To the Columbia County Commissioners,
 I believe there is an item in the NEXT proposal that has not received the scrutiny it deserves.
 The topic of my concern is the tall cylindrical structure standing alone in the field in the site rendering:

My search in the Columbia County Staff Report in DR 21-03 MOD & CU 23-11 NEXT Facility (RIPD/PA-80) for review criteria and findings **related to the proposed flare stack** has been futile. In the absence of flare stack information, the County's findings raise some red flags.

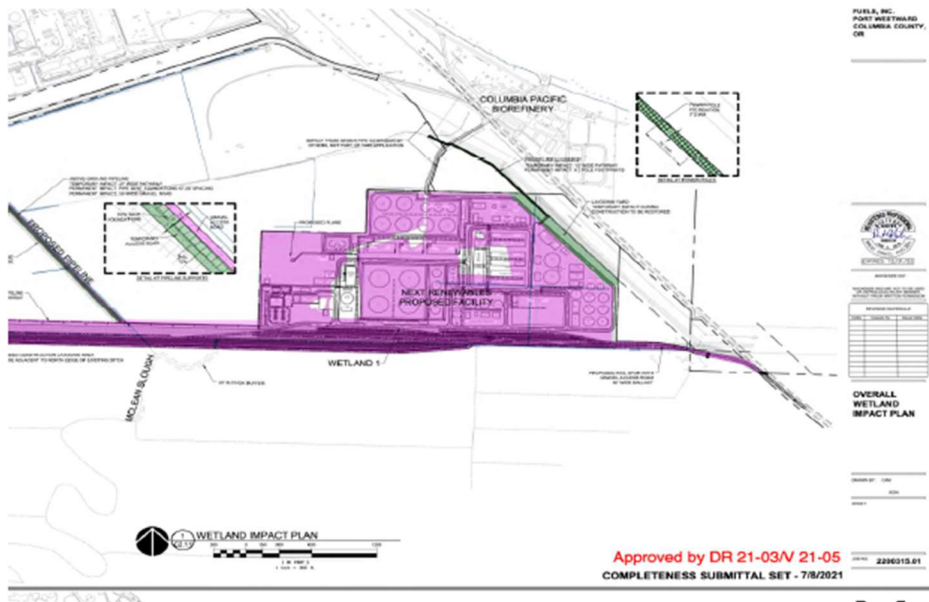
Note:
 A magnifying glass
 will confirm that the
 label says:
PROPOSED FLARE

Finding 17 on pg 16 of 48 does not address the proposed flare (flare stack). The site rendering and other drawings fail to provide suitable scale and dimensions of the proposed flare stack. Furthermore, the finding states, "Noise sources for the approved facility will utilize applicable mechanisms to limit volumes to no more than 85 decibels at the property line." Not only are the scale and the dimensions of the flare stack missing, but the County has not required any details from the applicant on how the flare stack will meet noise standards.

The County has failed to ascertain from NEXT Renewable Fuels how the flare stack will complement the character and development of the surrounding rural area. Addressing the flare stack separately is appropriate because it would be a landmark due to its height, flame and smoke.
